Site Plan Review

Site: 27601 Southfield Road
Applicant: Oakland Development, LLC
Plan Date: September 13, 2023
Zoning: VC Village Center District

Proposal: Commercial Building Renovation

SURNOW CO. - LATHRUP VILLAGE RENOVATION 27601 SOUTHFIELD RD. LATHRUP VILLAGE, MI EXISTING SITE AERIAL VIEW

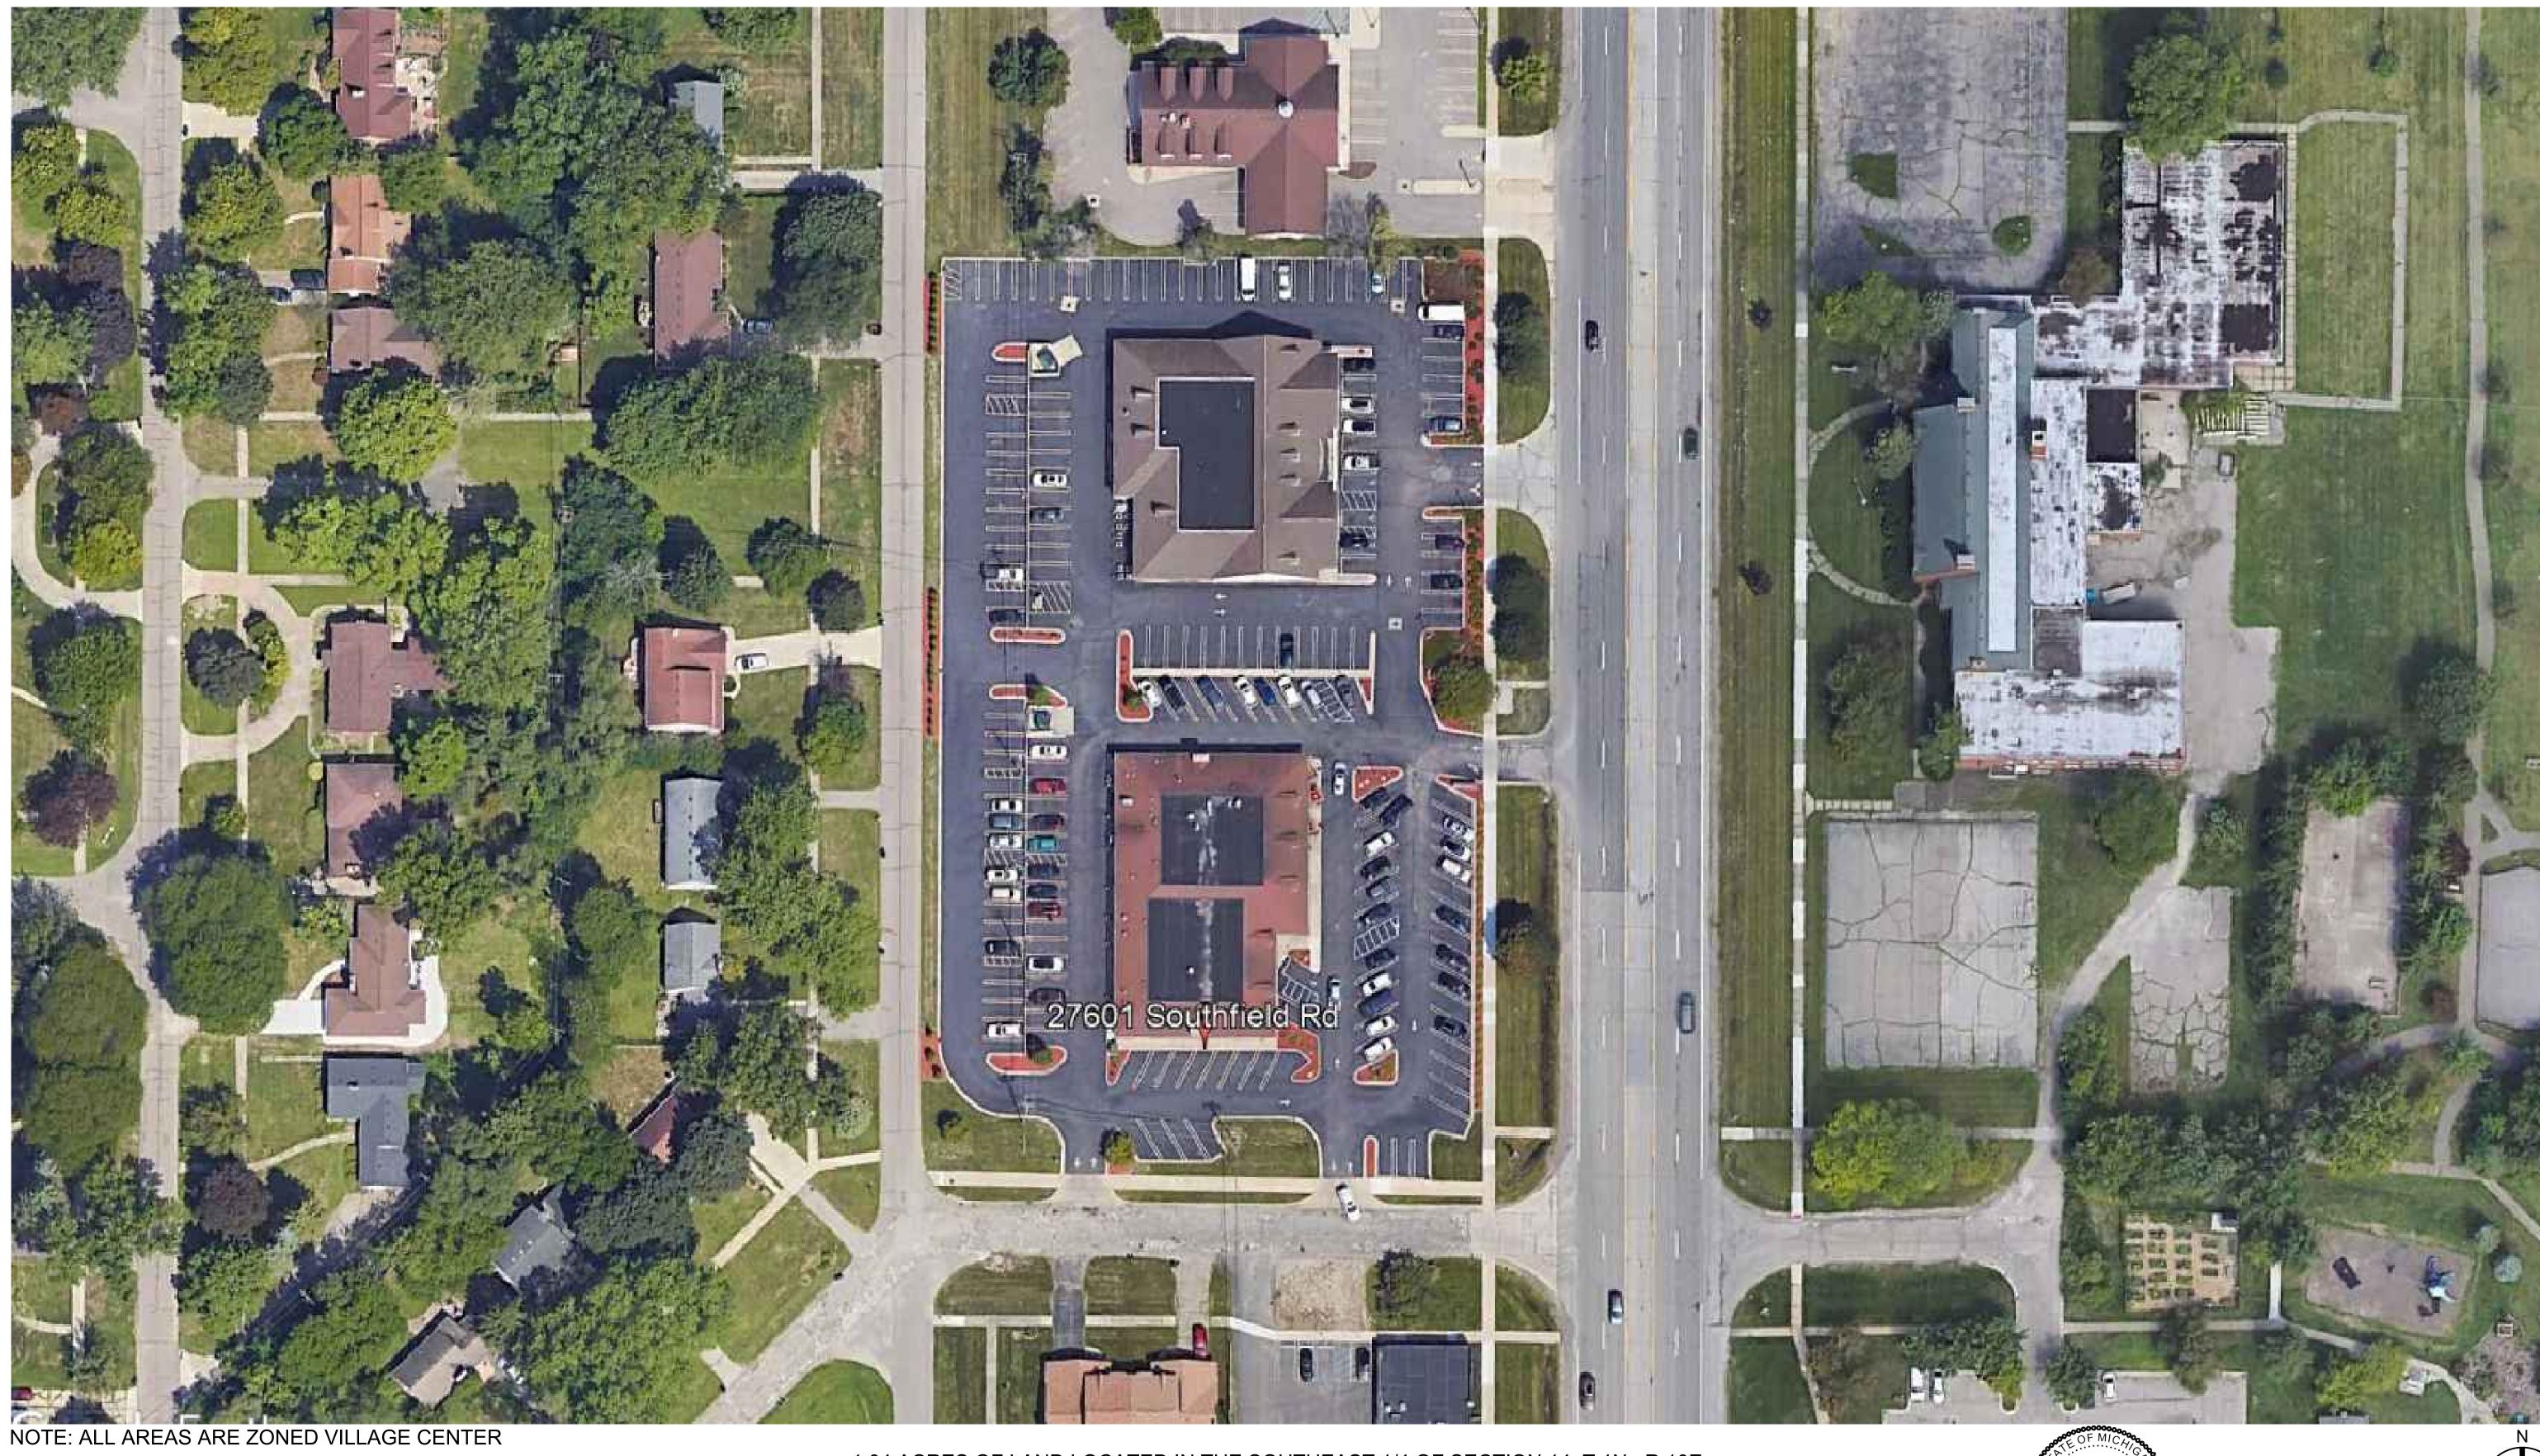
The existing dumpster enclosure, shown in the image above, is partially screened with a number of evergreen trees along a portion of the El Dorado Drive right-of-way. The Planning Commission may consider requiring the property owner to extend the evergreen screening along the El Dorado frontage to soften the views into the property from the street, and more particularly from the single-family residences on the west side of the street. The height of the dumpster enclosure appears to be lower than the dumpster and therefore may be less than the 6' height requirement.

PROPOSED ARCHITECTURAL SITE PLAN

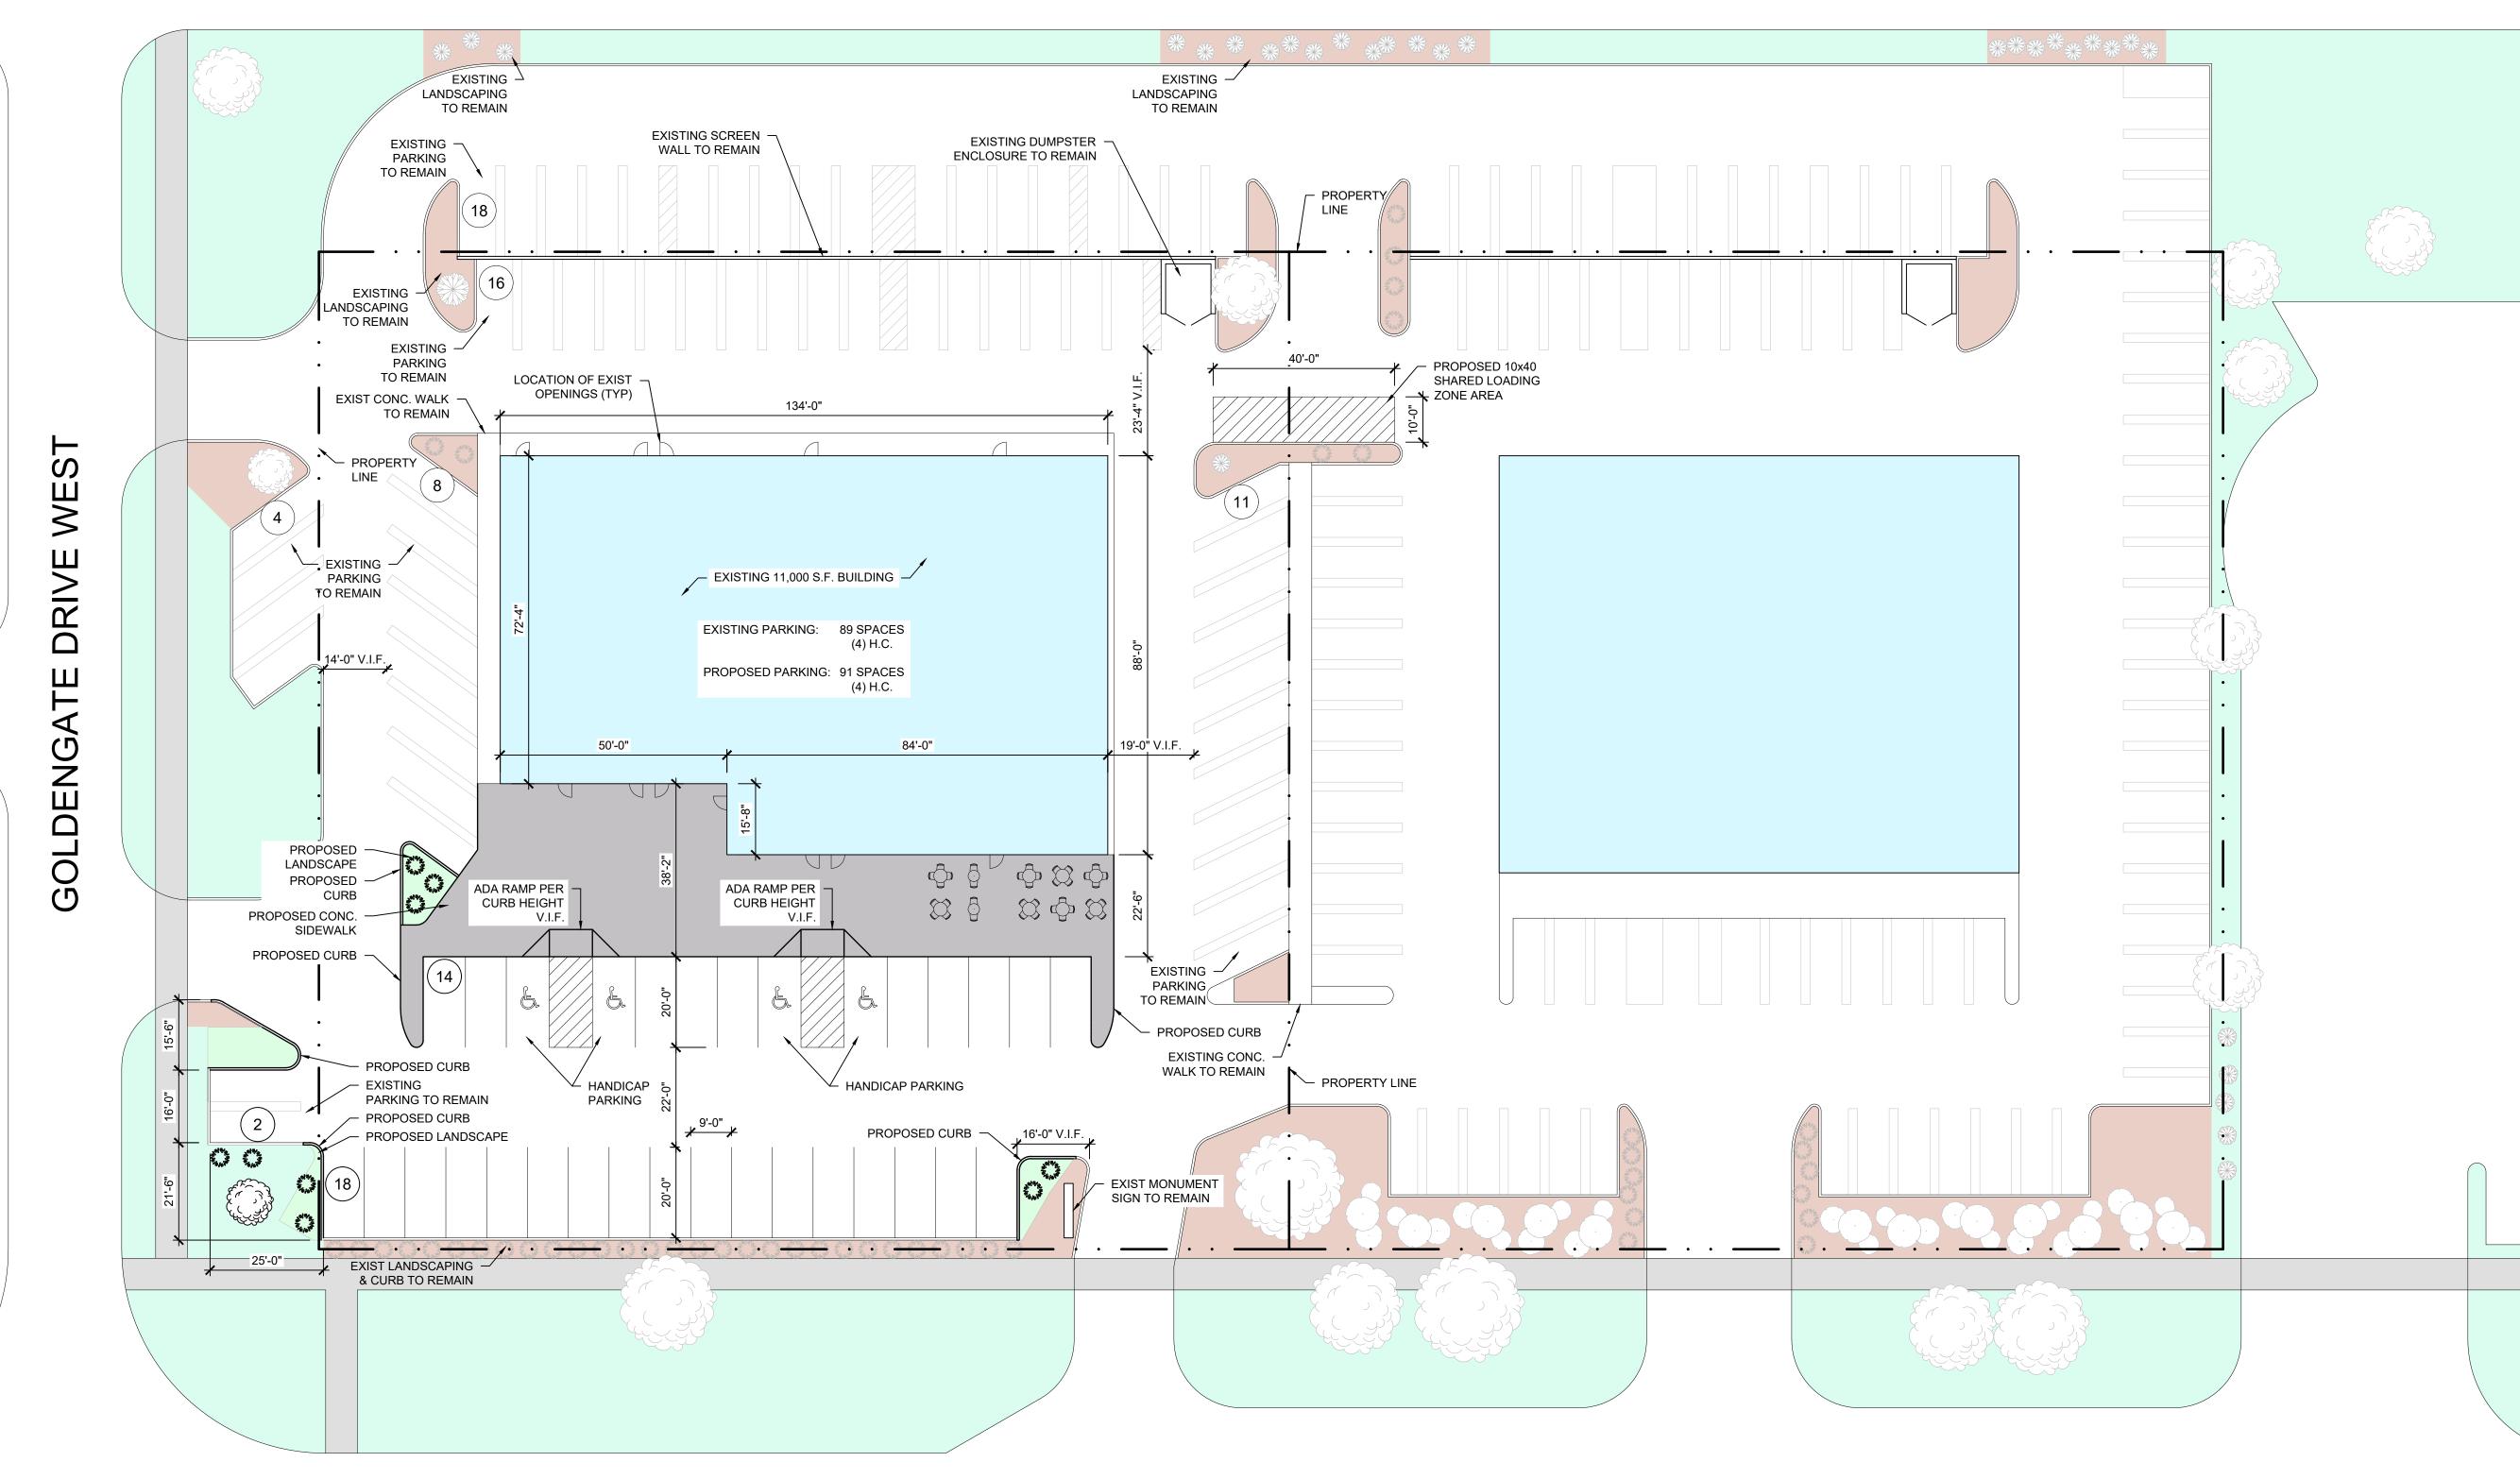
The off-street parking analysis provided requires 90 total parking spaces for the site (53 spaces for the restaurant tenant and 37 spaces for the retail tenant spaces). Modifications to the existing parking facility result in 67 proposed, on-site parking spaces and 24 on-street (El Dorado Drive and Goldengate Drive rights-of-way) to be maintained as-is, resulting in 91 total parking spaces to meet the 90-space parking requirement.

The site plan identifies the designated 10' x 40' loading zone straddling the property line between the subject site and the northern adjacent site, under common ownership of the applicant. As stated above, ordinance-required loading zones shall be independent and unobstructive to driveways, drive aisles, and parking spaces. The Planning Commission may wish to discuss the proposed location of the required loading zone, which is shown to partially obstruct drive aisles and access to the existing dumpster pad. We note that when the loading zone is occupied, the vehicular circulation of the combined sites does not appear to be hindered.
